SHOREHAM NUCLEAR POWER STATION

NRC-608

SHOREHAM NUCLEAR POWER STATION - UNIT I
Docket No. 50-322

ATTACHMENT A

Fig-3.1 HYDROGEN GAS PRODUCTION RATE BY RADIOLYSIS DUE TO VARIOUS FISSION PRODUCT SOURCES

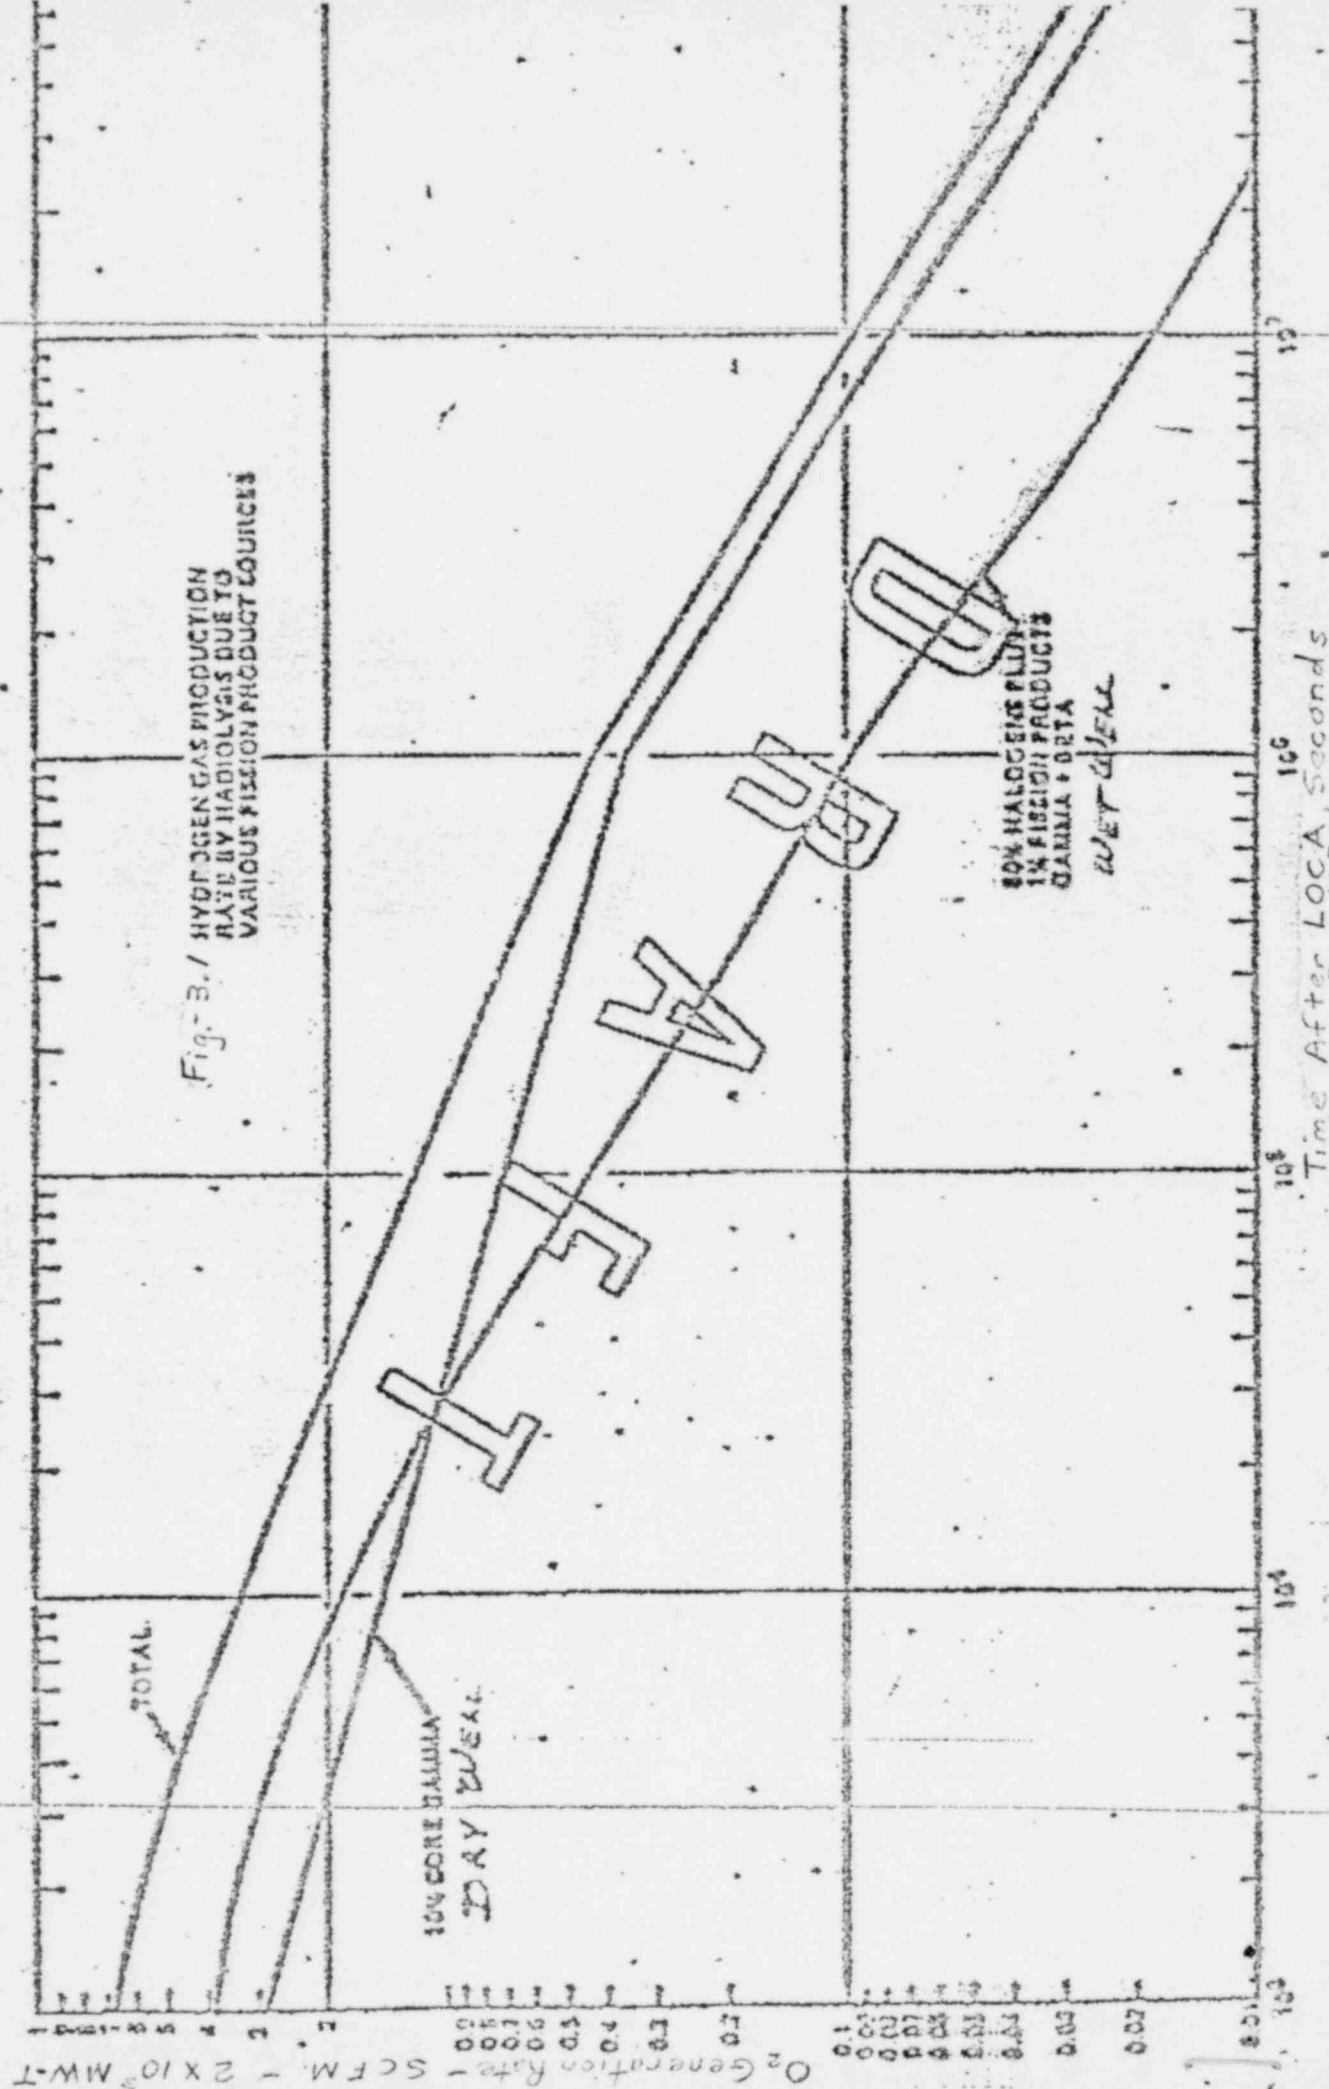
II.B.7 HYDROGEN CONTROL (ADDITIONAL INFORMATION)

1. The hydrogen recombiners will function with an inerted containment.
2. The recombiners will recombine 3 SCFM of oxygen with 6 SCFM of hydrogen.
3. Generation of oxygen results only from the radiolytic decomposition of water. The rate varies with temperature and location (drywell, wetwell).

The quantities (rates) are determined from Fig. 3.1 (attached) of Draft 4 of proposed standard ANSI-N-275, ANS 56.1 June 1976, "Containment Hydrogen Control".
